ADDENDUM #5
FORMAL BID 2020-115

KITSAP COUNTY PUBLIC WORKS WASTEWATER DIVISION
CENTRAL KITSAP TREATMENT PLANT MODULAR BUILDING ADDITIONS

Sheet Number
E1.01

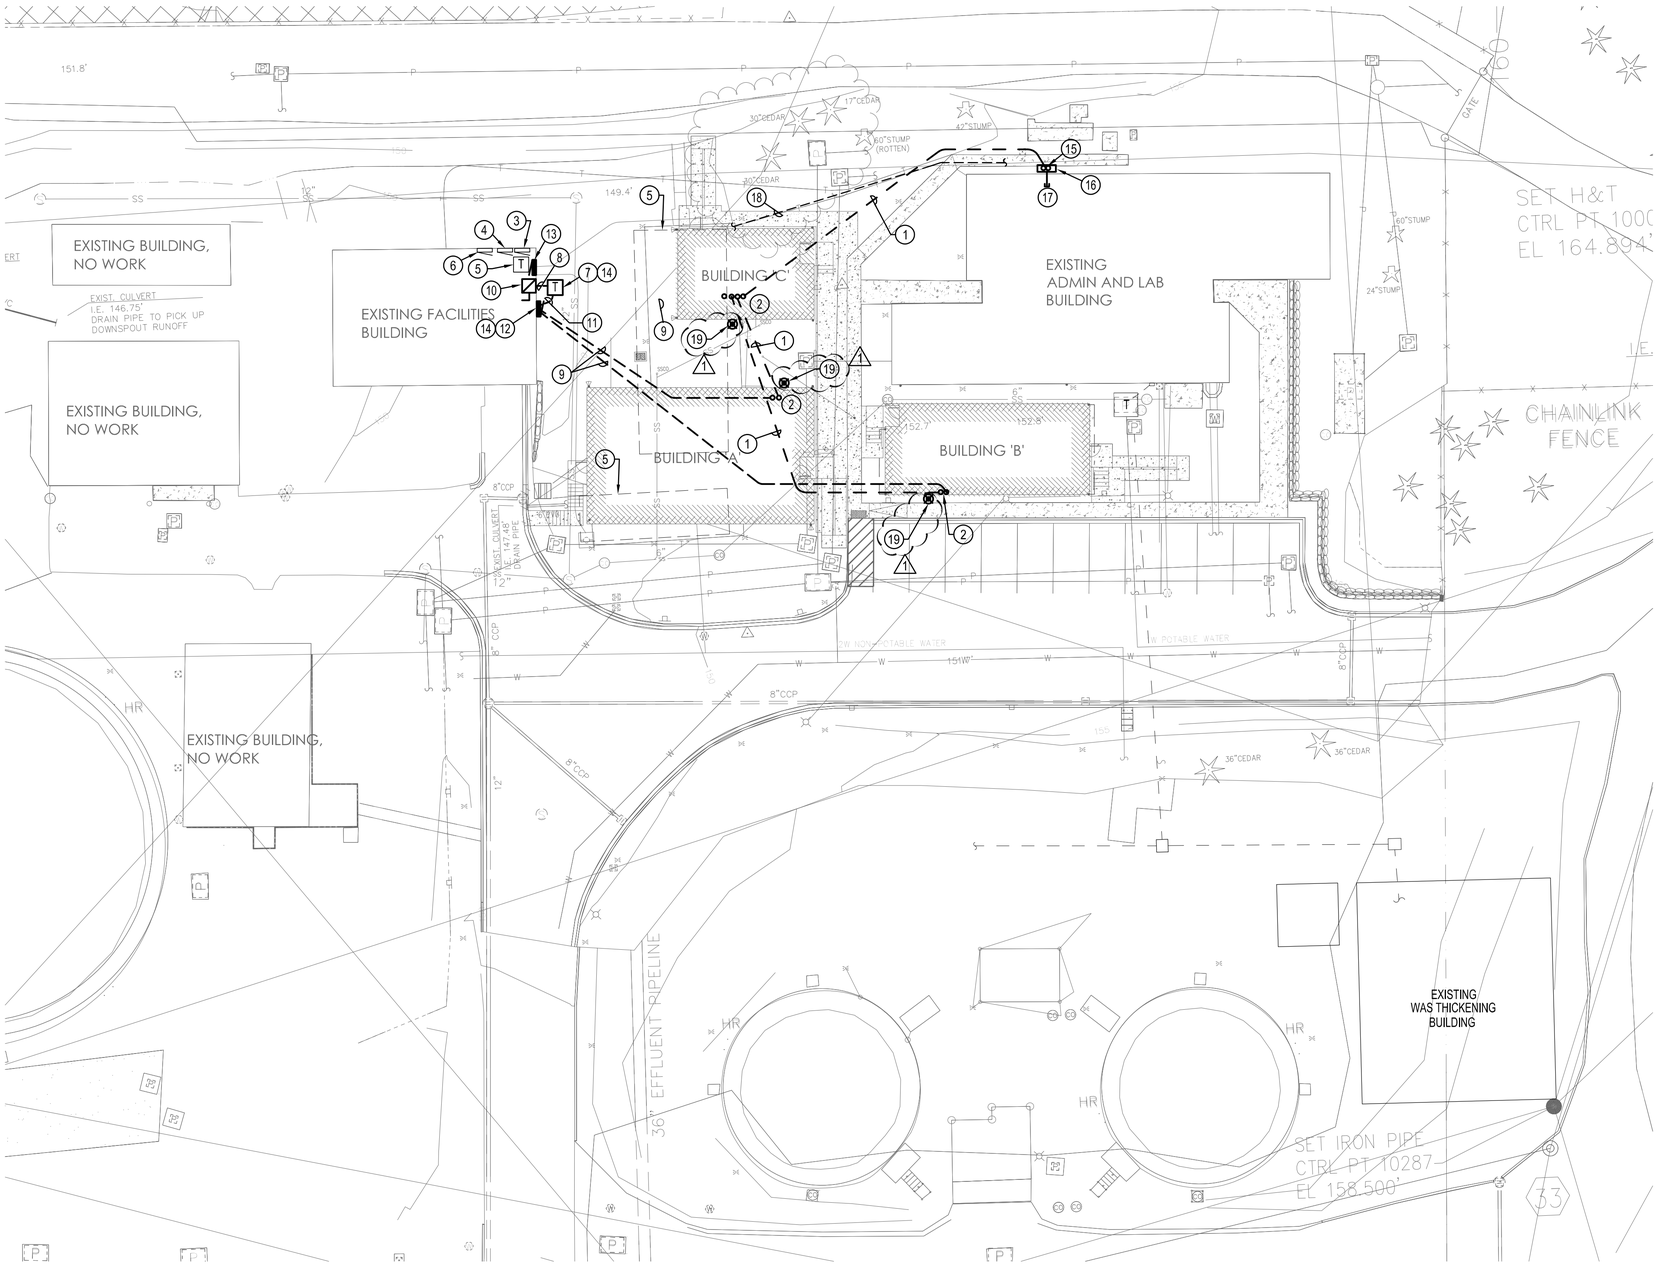
1. PROVIDE NEW CONCRETE ENCASED (2) 2-1/2" CONDUITS. FOR TELECOMMUNICATIONS BACKBONE CABLING. PROVIDE CONDUITS WITH PULLSTRING FOR OWNER'S CABLE INSTALLER.

15. STUB THE (2) 2-1/2" TELECOMMUNICATIONS CONDUIT ON THE EXTERIOR WALL OF THE EXISTING ADMIN/LAB BUILDING. 1
16. PROVIDE A 24"x24"x4" STAINLESS STEEL NEMA 4X JUNCTION BOX.

17. CORE DRILL AND PROVIDE (2) 2-1/2" CONDUIT SLEEVES INSIDE THE EXISTING TELECOM ROOM. COORDINATE EXACT LOCATION AND HEIGHT WITH THE OWNER. GROUT FILL ALL PENETRATIONS AND PAINT TO MATCH EXISTING ADJACENT SURFACES. 1

18. DISCONNECT AND REMOVE EXISTING TELECOM CABLES AND CONDUIT.
19. PROVIDE GROUND ROD WITH INSPECTION WELL. SEE SHEET E6.01 FOR THE POWER RISER DIAGRAM. 1

Sheet Number
E2.01

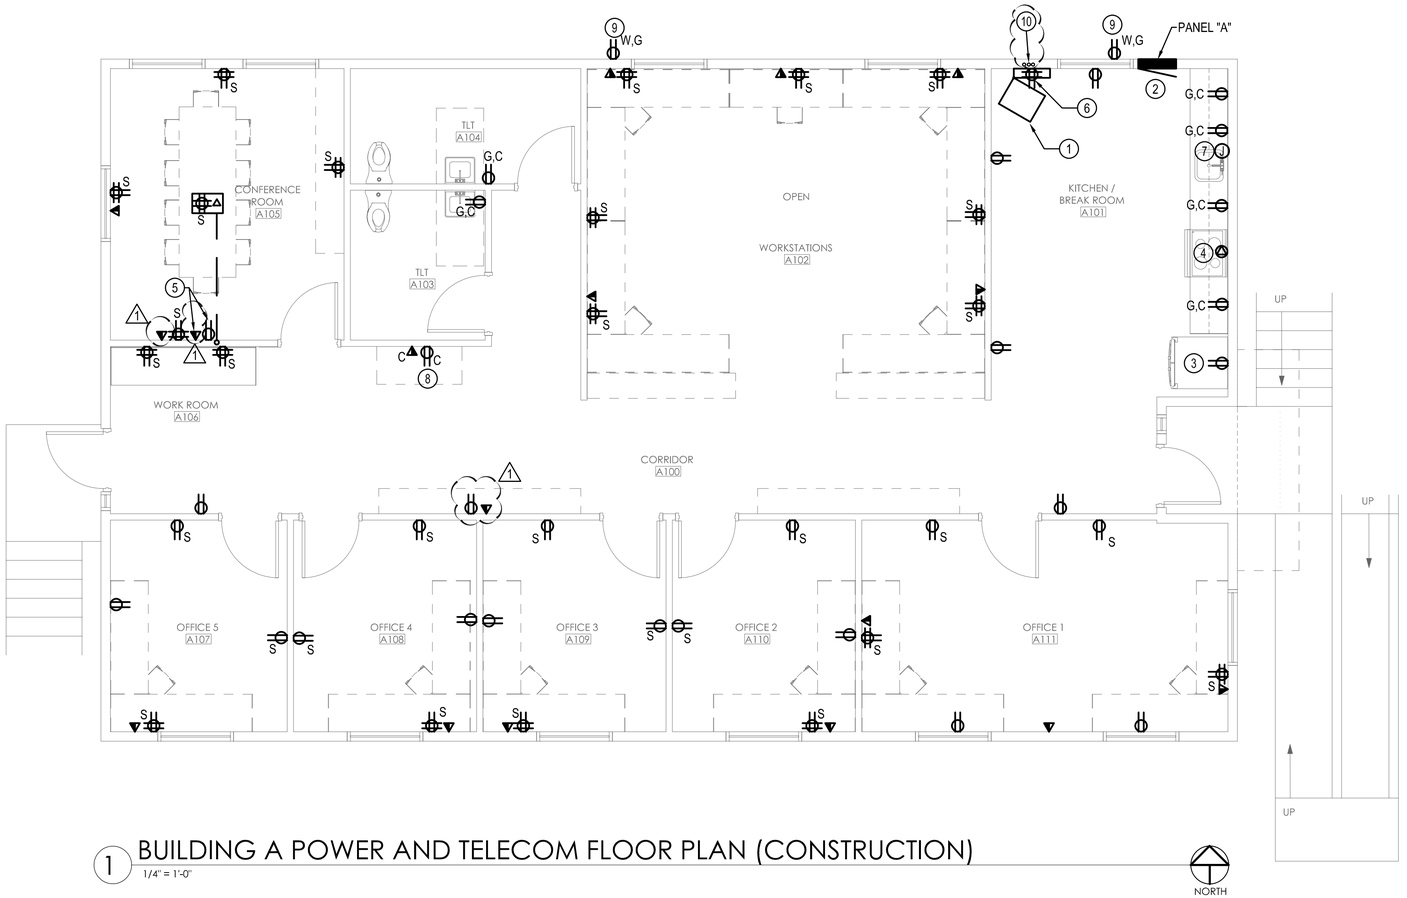
1. PROPOSED WALL MOUNTED TELECOM RACK LOCATION. PROVIDE 4'-0" SQUARE 3/4" THICK PLYWOOD BACKBOARD FOR TELECOM RACK MOUNTING. 1
2. PRE MANUFACTURED BUILDING SERVICE PANELBOARD 250A, 120/240V, 1Ø. EXACT LOCATION TO BE VERIFIED BY BUILDING MANUFACTURER.

3. RECEPTACLE FOR REFRIGERATOR.
4. RECEPTACLE FOR RANGE.
5. RECEPTACLE AND COMMUNICATION/DATA OUTLET FOR TV. COORDINATE EXACT LOCATION AND MOUNTING HEIGHT WITH THE OWNER. PROVIDE ROUGH-IN BACKBOX AND 1-1/4" CONDUIT TO THE ACCESSIBLE CEILING. 1

8. RECEPTACLE FOR PRINTER.
9. PROVIDE EXTERIOR DUPLEX RECEPTACLE OUTLETS TO BE ON A DEDICATED DEDICATED CIRCUIT, NOT SHARED WITH INTERIOR RECEPTACLES.
10. BUILDING MANUFACTURER TO PROVIDE (3) 2" CONDUIT SLEEVES (CONCEALED IN THE WALL) FROM THE RACK TO THE ACCESSIBLE CEILING SPACE. 1

E2.02

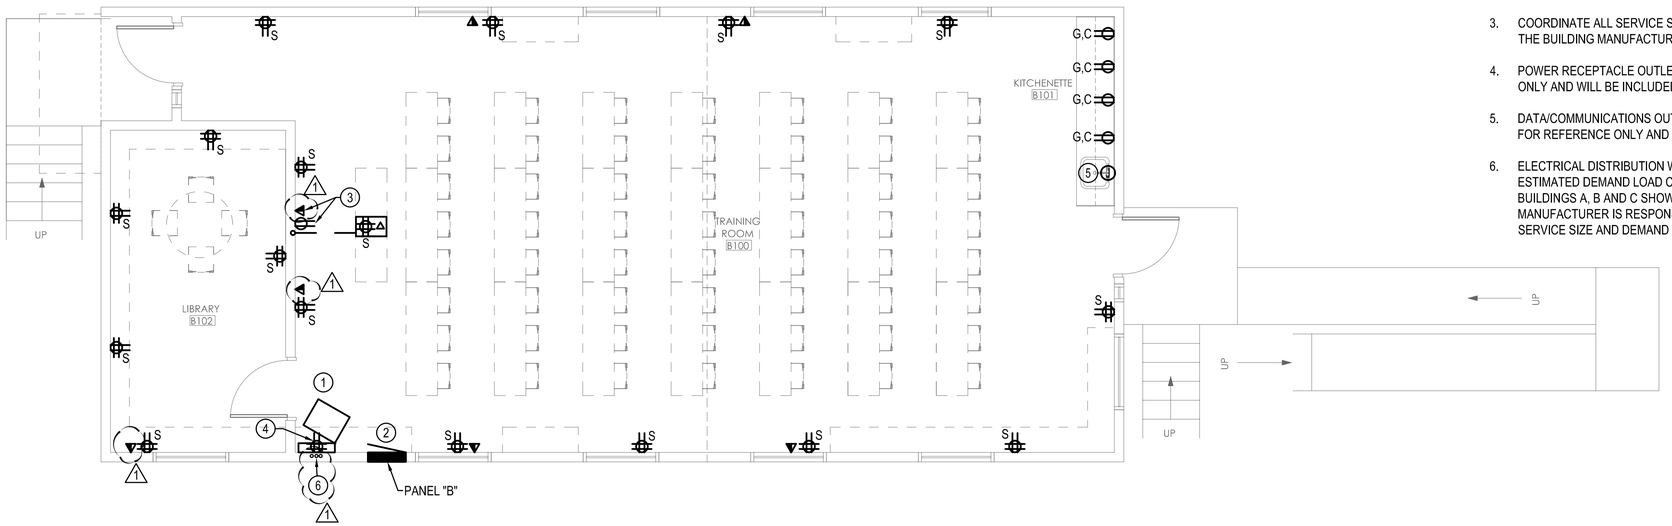
1. PROPOSED WALL MOUNTED TELECOM RACK LOCATION. PROVIDE 4'-0" SQUARE 3/4" THICK PLYWOOD BACKBOARD FOR TELECOM RACK MOUNTING. (1)
2. PRE MANUFACTURED BUILDING SERVICE PANELBOARD 200A,120/240V, 1Ø. EXACT LOCATION TO BE VERIFIED BY BUILDING MANUFACTURER.
3. RECEPTACLE AND COMMUNICATION/DATA OUTLET FOR TV. COORDINATE EXACT LOCATION AND MOUNTING HEIGHT WITH THE OWNER. PROVIDE ROUGH-IN BACKBOX AND 1-1/4" CONDUIT TO THE ACCESSIBLE CEILING.
4. RECEPTACLE FOR TELECOM RACK. COORDINATE EXACT LOCATION AND MOUNTING HEIGHT WITH TELECOM RACK INSTALLER.
5. POWER CONNECTION TO TANKLESS WATER HEATER.
6. BUILDING MANUFACTURER TO PROVIDE (3) 2" CONDUIT SLEEVES (CONCEALED IN THE WALL) FROM THE RACK TO THE ACCESSIBLE CEILING SPACE. (1)

Sheet Number
E2.03

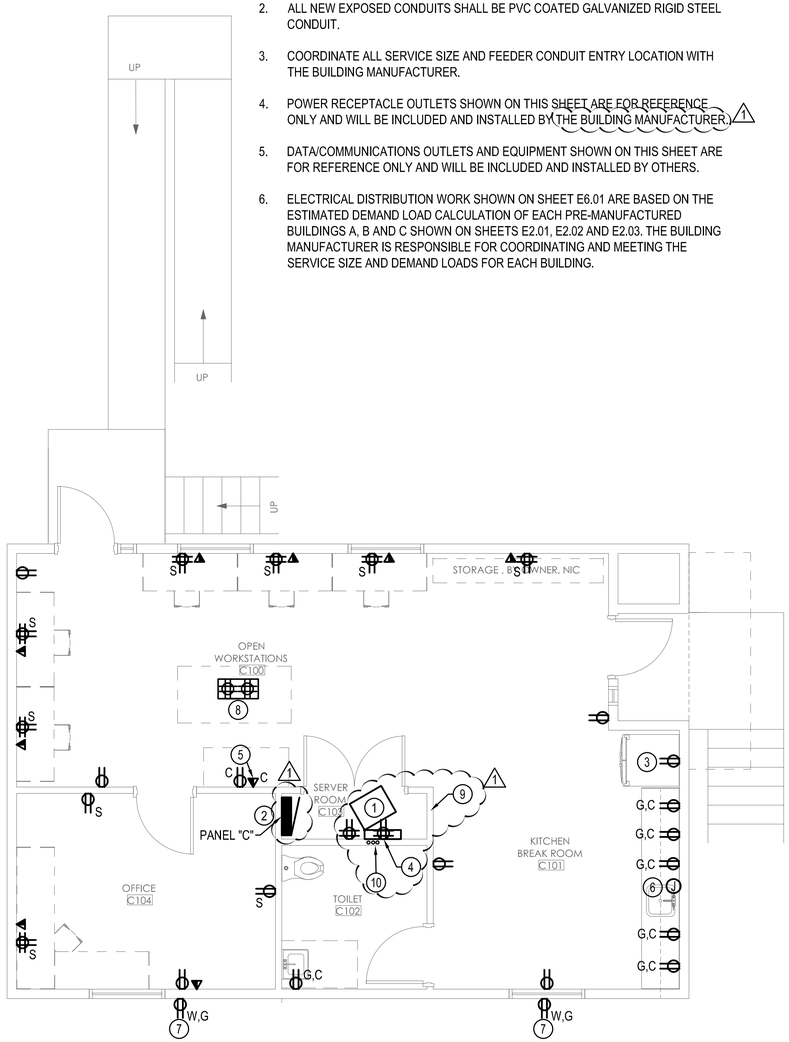
1. PROPOSED WALL MOUNTED TELECOM RACK LOCATION. PROVIDE FULL HEIGHT 3/4" THICK PLYWOOD BACKBOARD ON SOUTH AND EAST WALLS FOR TELECOM EQUIPMENT AND CABLING. (1)

9. TELECOMMUNICATIONS BACKBONE CONDUITS ENTERING SERVER ROOM C103 SHALL BE ALIGNED PARALLEL TO THE EAST WALL.
10. BUILDING MANUFACTURER TO PROVIDE (3) 2" CONDUIT SLEEVES (CONCEALED IN THE WALL) FROM THE RACK TO THE ACCESSIBLE CEILING SPACE. (1)
